CITY PLAN COMMISSION

FILE NUMBER: PLAT-25-000090 (S245-243)

REQUEST: An application to create one 4.3510-acre lot from a tract of land in City Block 8502 on property located on St. Augustine Road south of LBJ Freeway.

PRELIMINARY PLAT
PASTURAS LOS ALZANES - ST. AUGUSTINE ADDITION
LOT 1, BLOCK A/1892
4.3810 ACRES SURVEY, ABSTRACT NO. 1718
CITY OF DALLAS, DALLAS COUNTY, TEXAS
CITY PLAN FILE NO. PLAT-25-000090 & S245-243
APRIL 25, 2025
 SHEET 1 OF 2

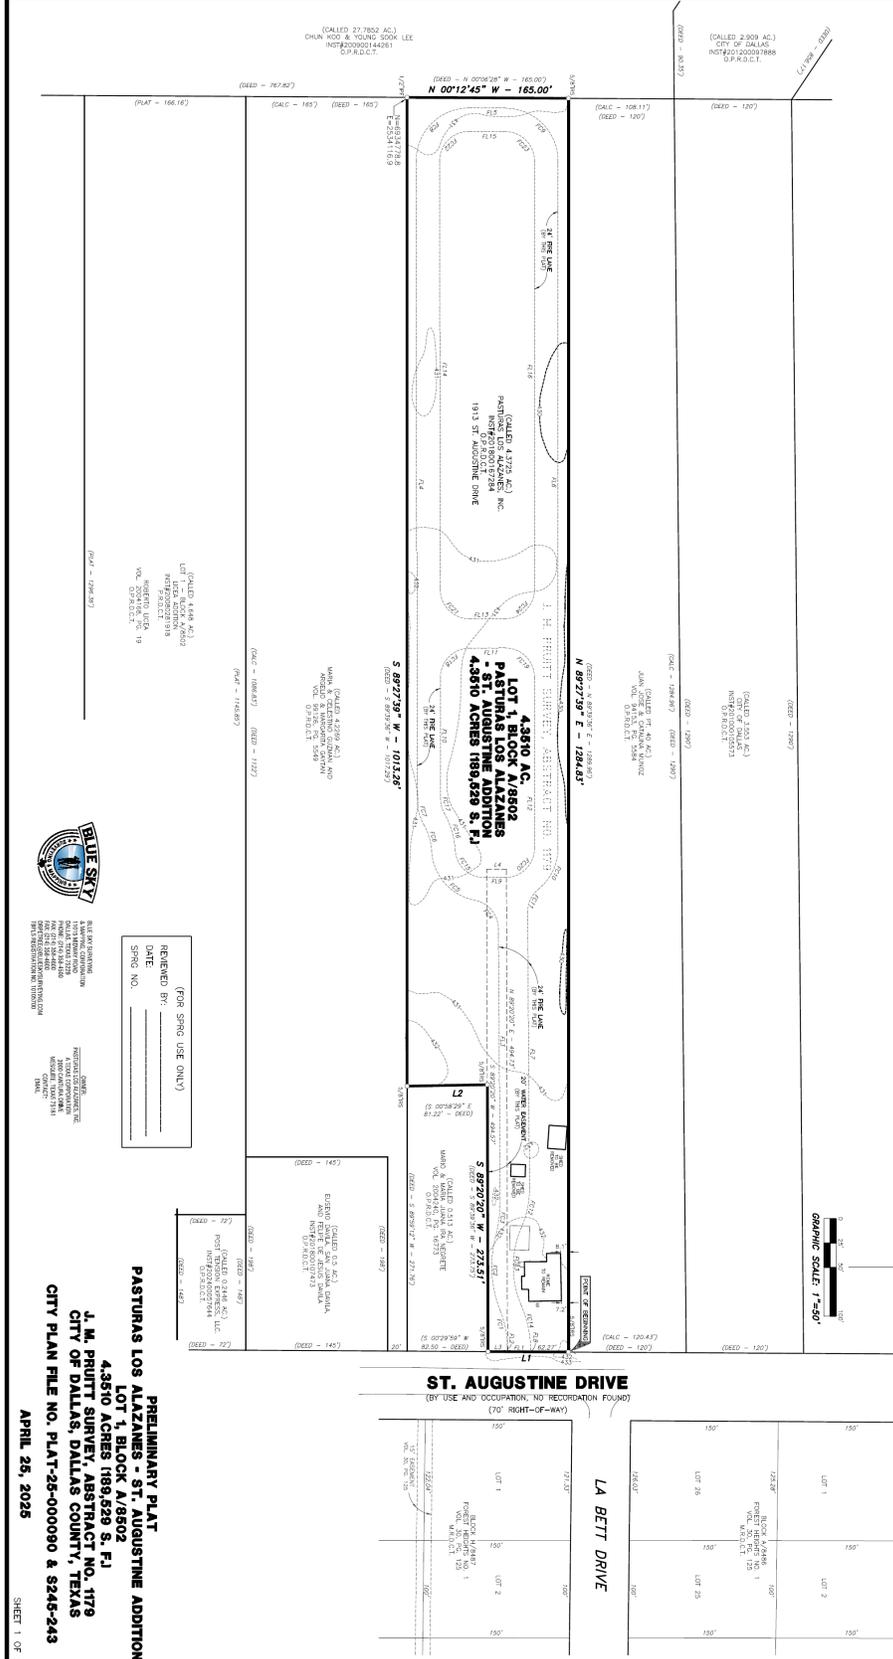
21. Additional design information is required for assessment. Site plan must be submitted showing proposed development, building finished floor elevation, development, existing mains – including downstream manhole, and proposed water and wastewater service locations. Submit water/wastewater engineering plans to 320 E. Jefferson Blvd., Room 200, Attention: Water and Wastewater Engineering.

22. Water main improvements is required by Private Development Contract. Submit water/wastewater engineering plans to 320 E. Jefferson Blvd., Room 200, Attention: Water and Wastewater Engineering.
23. Existing and any proposed Water and Wastewater Easements must be shown and/or increased to conform to current design standards. **Notice:** Minimum DWU easement size 20' for one utility and 25' for both water and sewer. Larger diameter or deeper mains may require additional width.

24. Prior to final plat, additional design information needed to complete review. Provide a brief description of the proposed project and a copy of the site plan to daniel.silva1@dallas.gov to determine street lighting requirements.
25. On the final plat, identify the property as Lot 1 in City Block 8/8502.
